Hallsville School District

All Purpose Field & Parking Lot Primary School Classroom Addition Secure Entry Doors

Progress Report #1

SUPPLEMENTAL INSTRUCTION 1 (SI 1)

SHEET **C505**

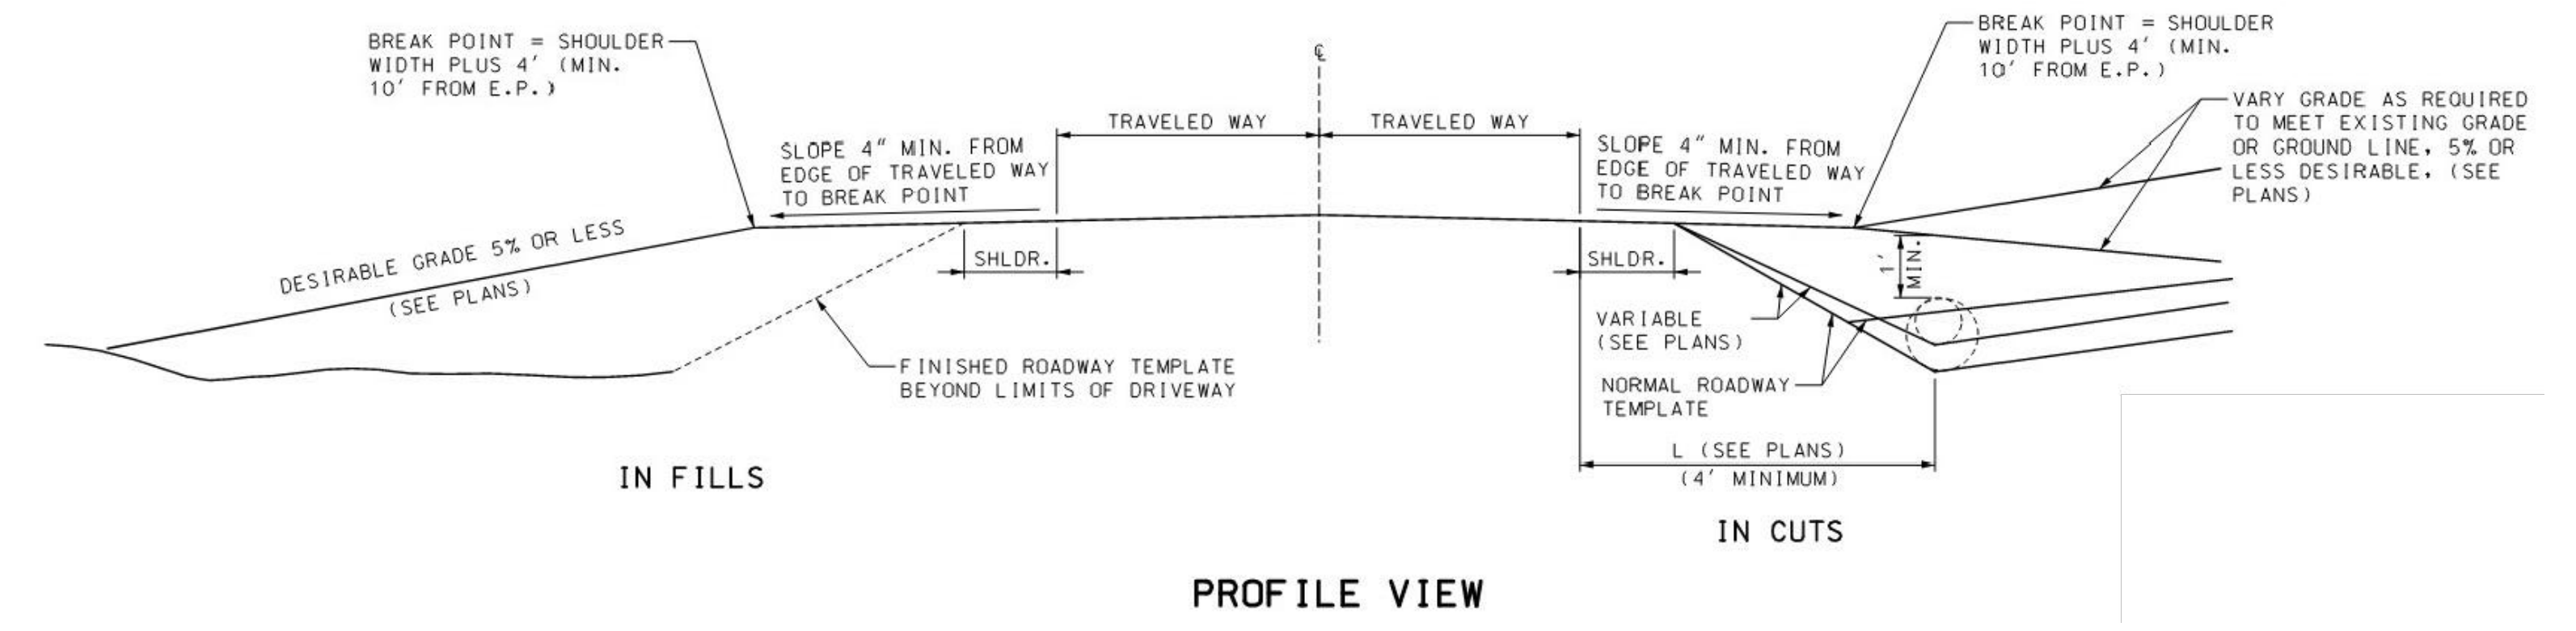
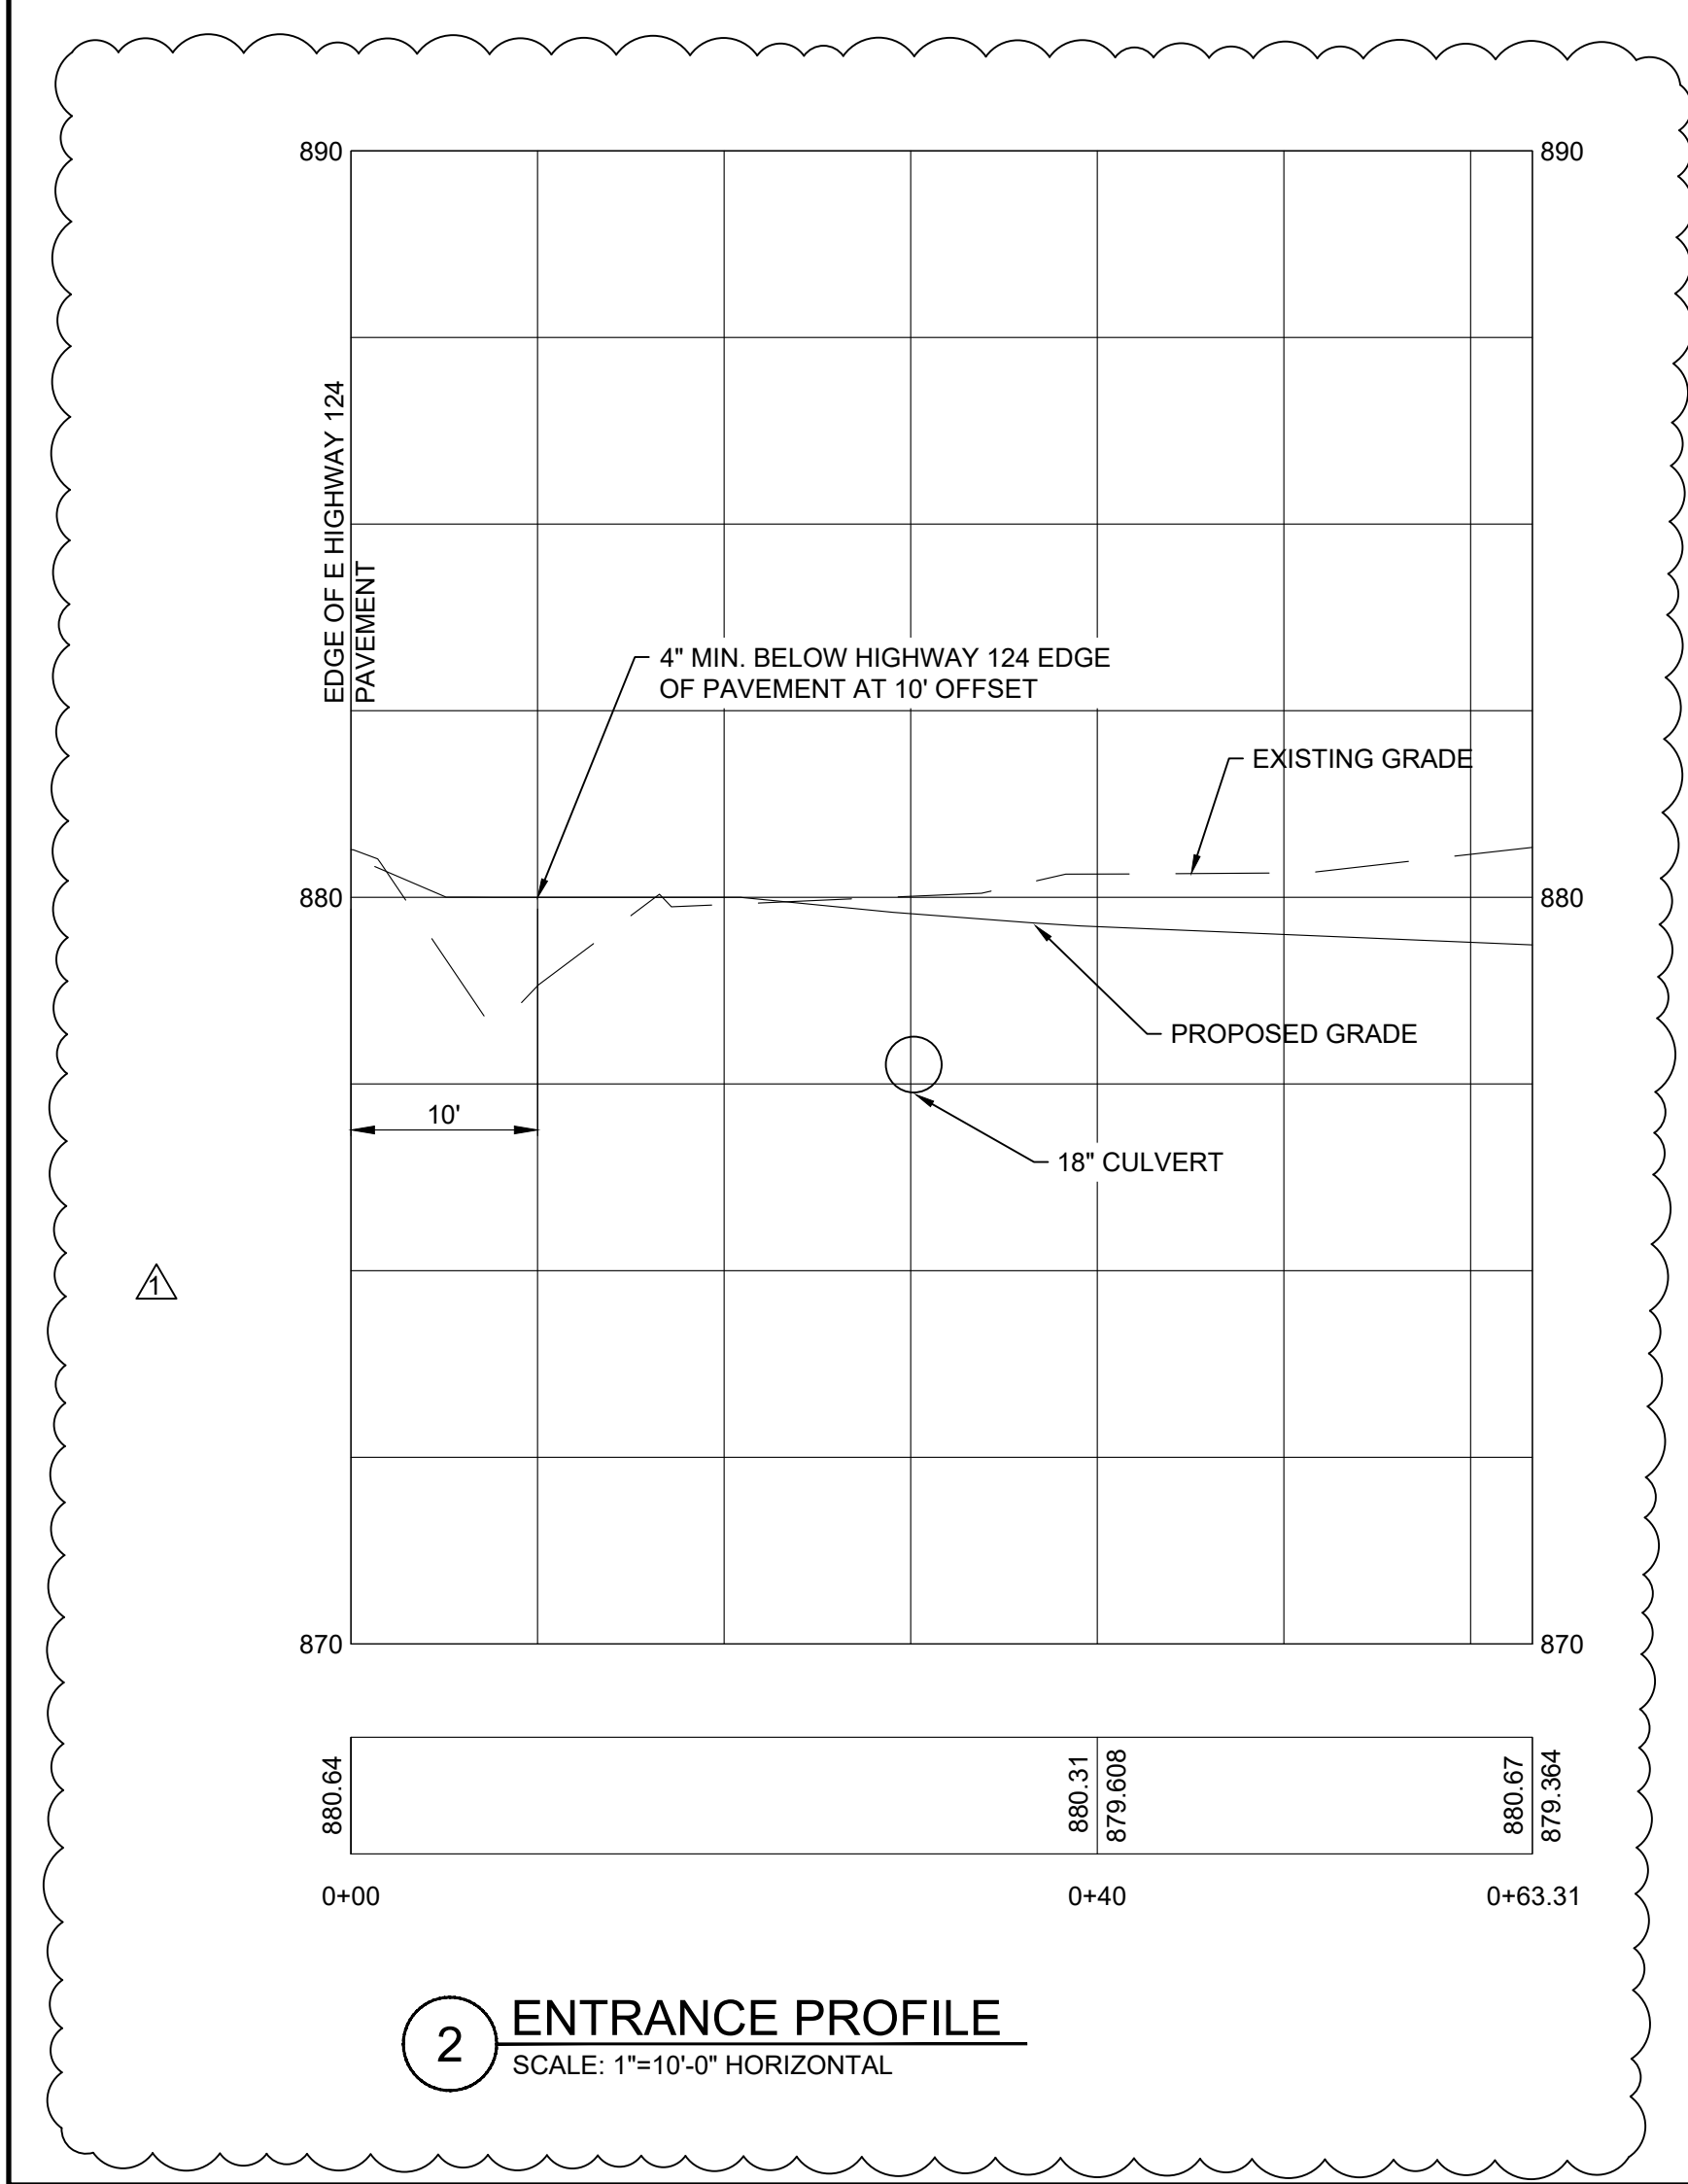
| 7 | Sheet C505 | Added fiberoptic relocation. Moved culvert fully within right-of-way. Moved stop sign and stop bar. |

| NO. | DESCRIPTION | DATE | BY |
|-----|--------------------------------|------------|-----|
| 2 | REVISED FIBER OPTIC RELOCATION | 2/22/26 | DCD |
